**CITY OF WEST DES MOINES
STAFF REPORT COMMUNICATION**

ITEM: Lot 2, West Lakes Office Park Plat 15, 7120 University Avenue – Approve Site Plan to allow construction of a multi-tenant retail building – Fore Right, L.C. and West Lakes Commercial, LLC – SP-006070-2023

Resolution: Approval of Site Plan

1 NORTH ELEVATION
1/8" = 1'-0"

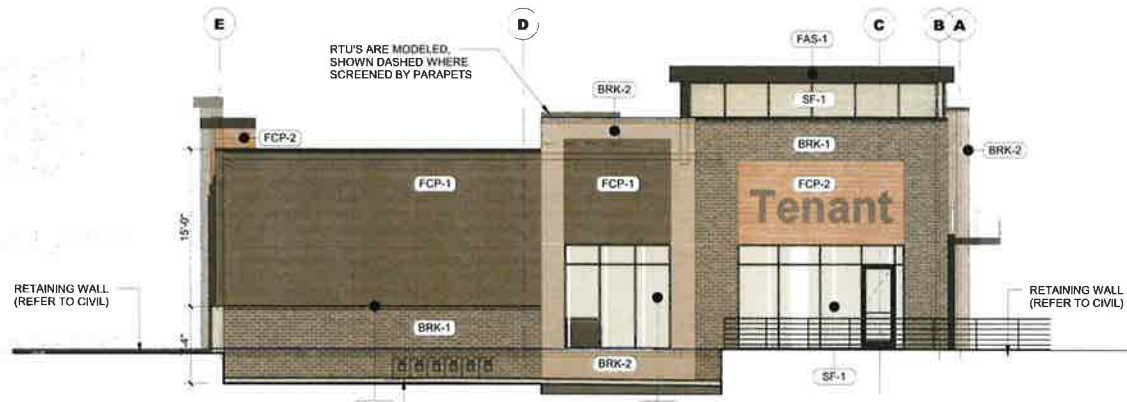
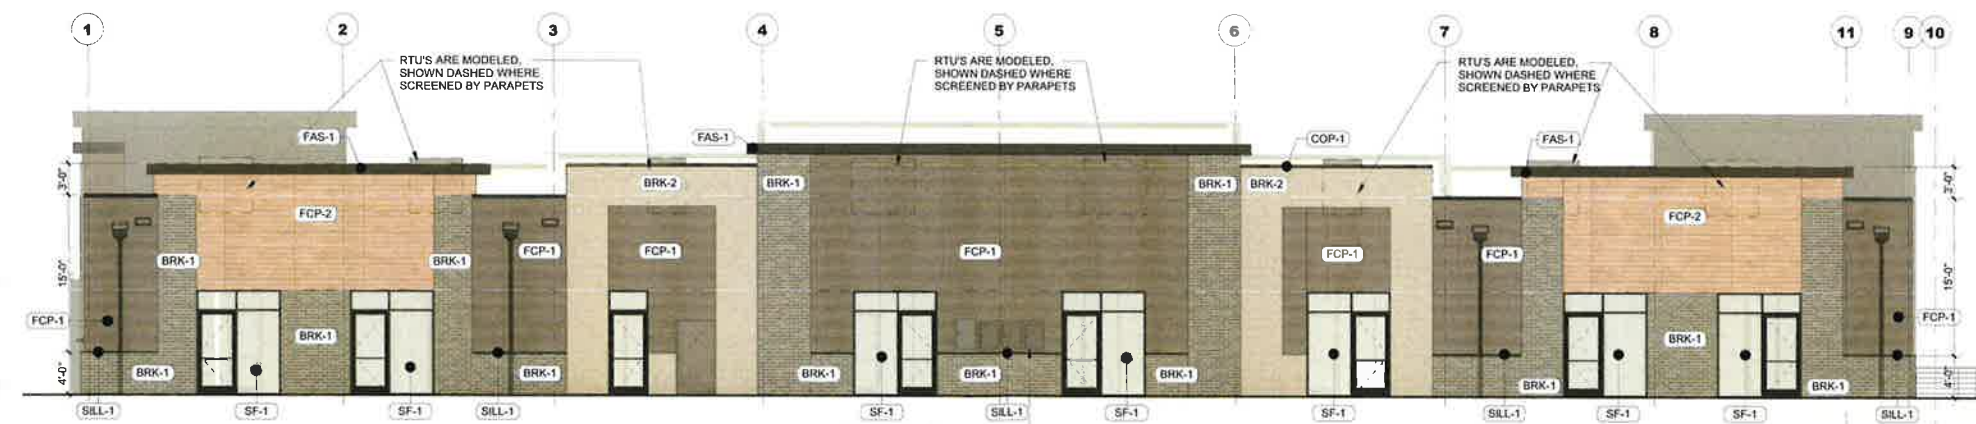
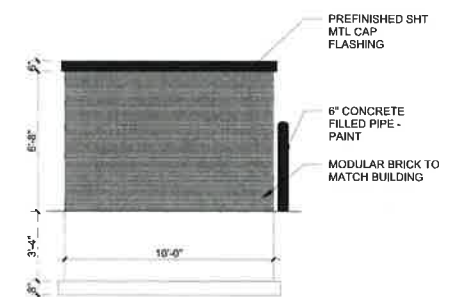
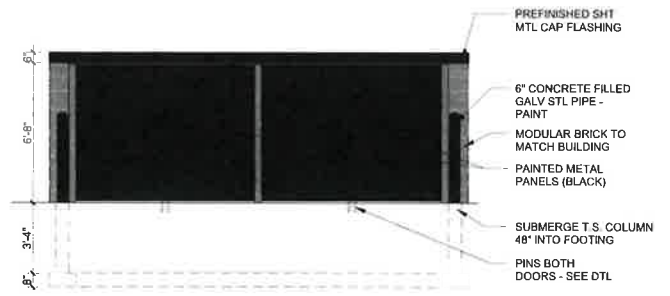
- **Key Development Aspects:**
 1. **Architecture:** The multi-tenant building uses a two tone brick design in black velour and lighthouse velour as the primary materials for the building design. Along with varying building heights and clear glass tower elements at each end, the building is accented with metal and composite fiber cement panel systems to provide visual interest and to help break of the size of the building into modular elements. The building provides black trim, storefronts and linear black metal awnings to accent and highlight the entry areas of the building.
